**PLANNING COMMISSION CONDITIONAL USE SITE PLAN
REVIEW SHEET**

CASE NUMBER: SP-2022-0197D **PC HEARING DATE:** August 8, 2023

PROJECT NAME: COUNTRY CLUB CREEK TRAIL - ELMONT DR. TO E. OLTORF ST.

RE: Country Club Creek Trail (Elmont Dr. to E Oltorf St.) – Minor Modification to Variance Condition #1

Figure 1. Example of updated wayfinding signs

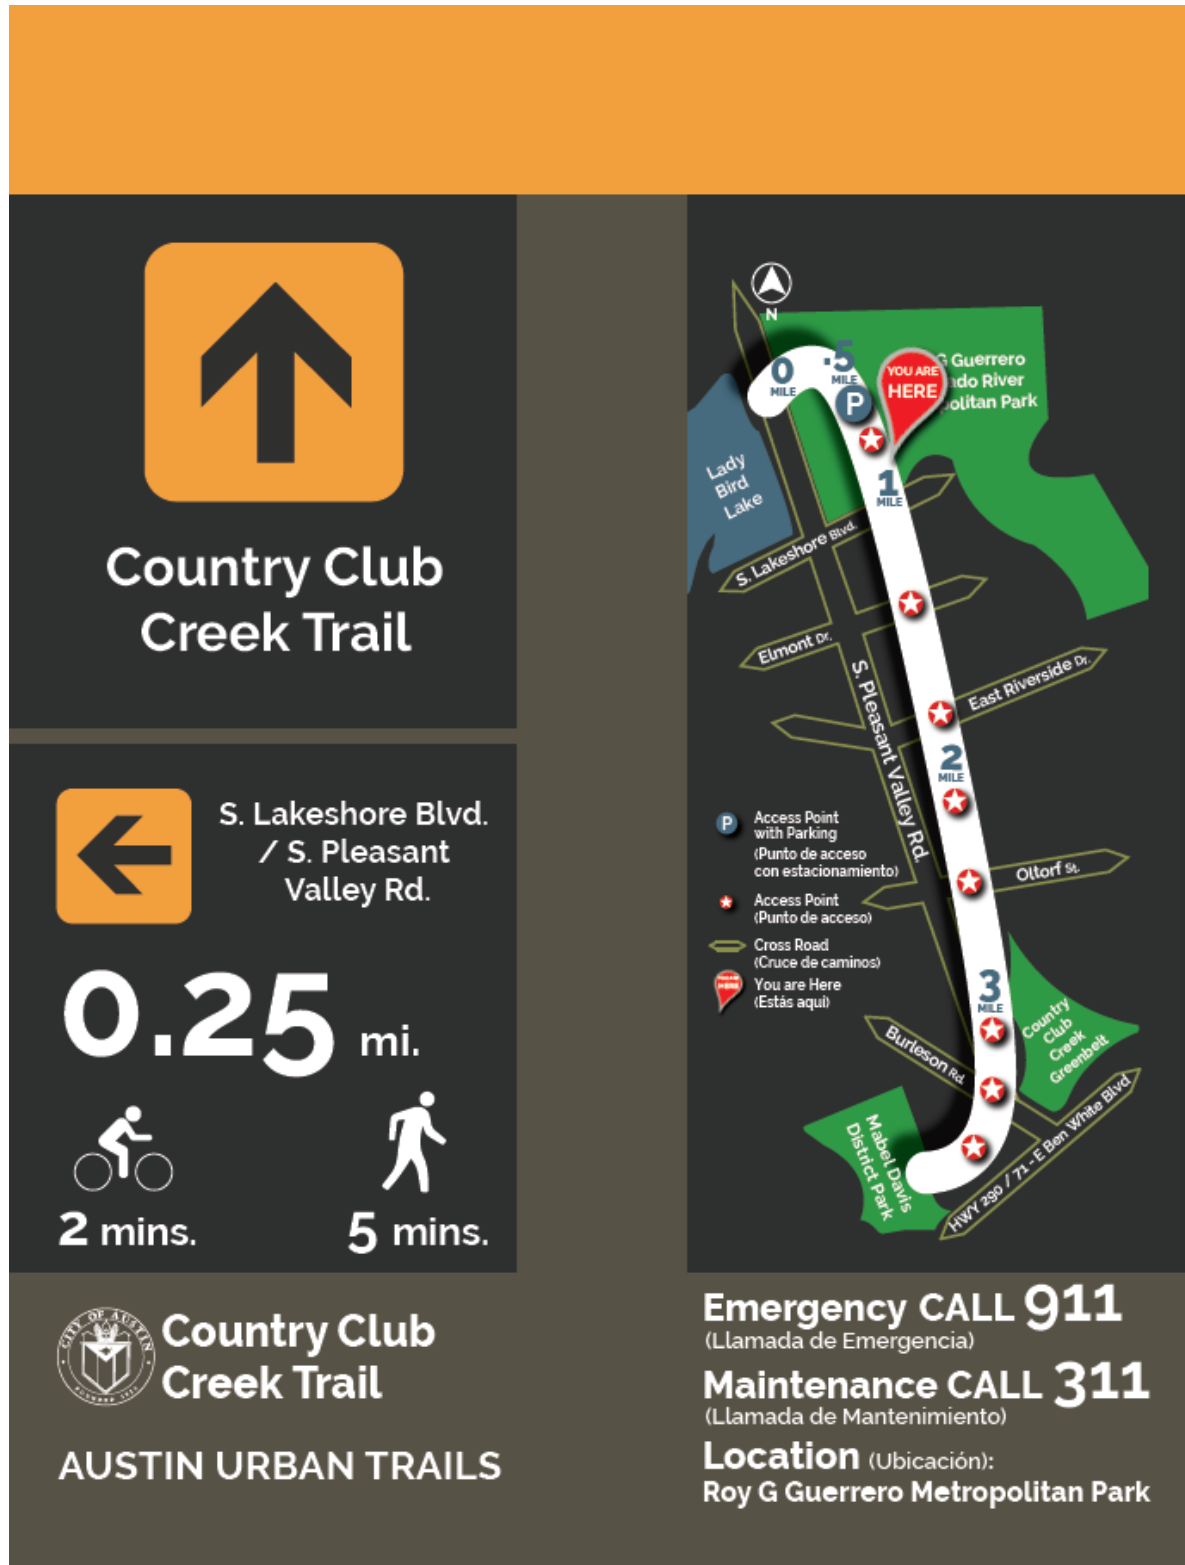
Condition #1: Include Spanish and English way-finding signs

Requested minor modifications: Include *emergency and maintenance information in* Spanish and English *on* wayfinding signs

The project's wayfinding signs comply with the Condition #1 by including emergency and maintenance information in English and Spanish and adding Spanish translation to the map legend (Figure 1). The intent for the wayfinding signs is to provide largely pictorial information that can be understood regardless of language. This wayfinding standard is used across Urban Trails projects citywide with approval from Austin Parks and Recreation's wayfinding team.
